Item ID: 647.0117 Accept *N900040100* Setup Start *NS1*
 Revision ID: Stop *NS2*
 Item Name: Strut Bracket
 Start Date: 11/4/2014 Start Qty: 50.00 *50* Cust Item ID:
 Required Date: 11/4/2014 Req'd Qty: 50.00 *50* Customer:
 Reference:

APICAL INDUSTRIES, INC.	ENGINEERING CHANGE NOTICE NO. 03985			SHEET 1 OF 2	
	DWG NO. 647.0100	REV: A	PREPARED BY J. BECKER	DATE: 7/15/13	EFFECT ON DWG ☐ INC. ☒ UNINC.
	DWG TITLE: SHEET METAL				
	APPROVED BY: ENGR 	MFG 	QC 	EFF. NEXT ORDER	
TRANSACTION CODES (TC): A-ADD R-REVISE C-CREATE D-DELETE	REASON: REVISED NOTE 2. ADDED 647.0117

SHOP COPY
RETURN TO
ENGINEERING
UNCONTROLLED COPY
SUBJECT TO AMENDMENT
WITHOUT NOTICE
WORK ORDER
NO 126235 MLC
14-11-04

SHEET 1, ZONE D1 IS:

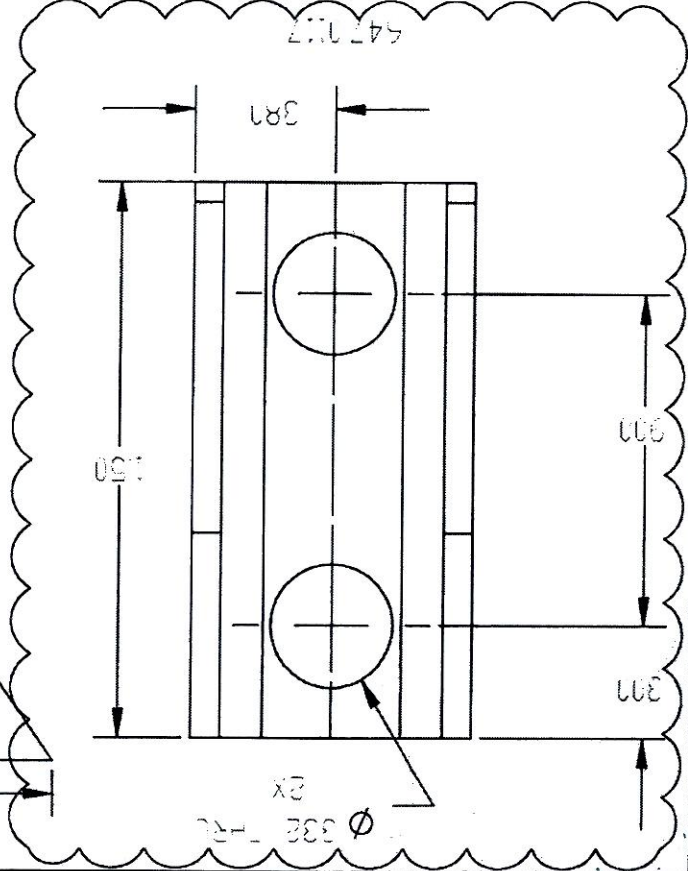
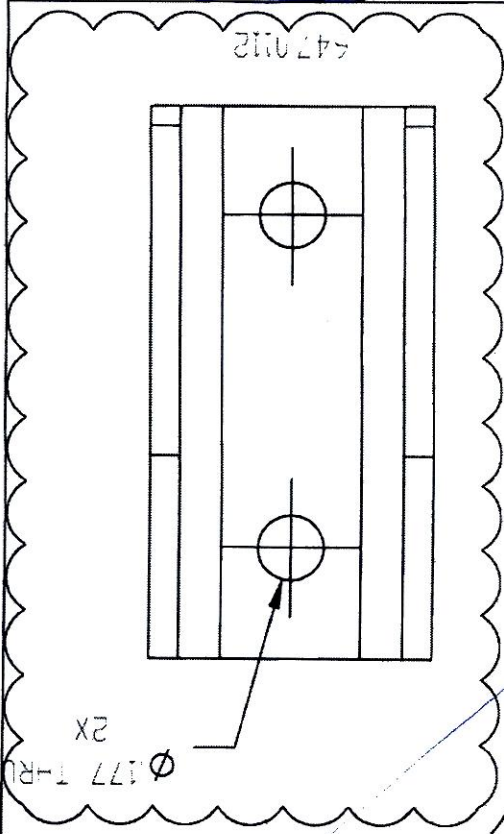
C	647.0117	STRUT BRACKET		△	△
F/NTC	PART NUMBER	DESCRIPTION	MATERIAL	SPECIFICATION	
DOCUMENTS EFFECTED:			CHANGE CATEGORY	DER REVIEW REQUIRED	
☐ MDL ☐ INSTALL INSTRUCTIONS ☐ ICA ☐ FMS ☐ BOM			☐ MAJOR ☒ MINOR	☐ YES ☒ NO

- 1 MATERIAL: ALUMINUM 2024-T3 PER AMS-QQ-A-250/4.
- 2 FINISH: IAW MPP-172 ANODIZE IAW SECTION 2.1,
PRETREATMENT IAW SECTION 3.1
AND PRIMER IAW SECTION 4.1.
3. DEBURR AND BREAK ALL SHARP EDGES.
4. IDENTIFY IAW MPP-120.
- 5 MATERIAL: 304 SS IAW AMS 5643.
- 6 FINISH: PRIME IAW MIL-P-23377J TYPE I CLASS N.
- 7 OTHER DIMENSIONS SAME AS 647.0112.
